**Chemung County Stormwater
Construction Inspection
Erosion and Sediment Control**

Project Name Horseheads Hotel	Date 11-15-19
Location State Route 14 Horseheads (V), NY	Permit # NYR10Y122
Weather Conditions sunny, cold	Entry Time: 10:35 am
On-Site Representative Present: Mike Bezon	Exit Time: 10:55 am

PROJECT: Horseheads Hotel
Village of Horseheads
Municipal Construction Inspection
November 15, 2019

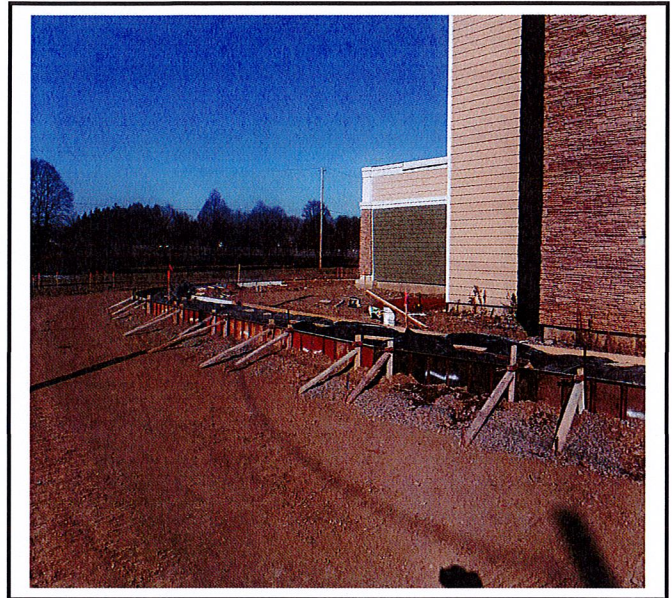
Construction entrance needed at first location off pavement. Too much sediment is getting tracked off site.

Concrete washout is required. Sidewalks have been poured and there is no washout at this time.

Catch basin grate is required for safety but inlet protection is required to prevent sediment and debris from getting into stormwater basin.

Drop inlet protection required.
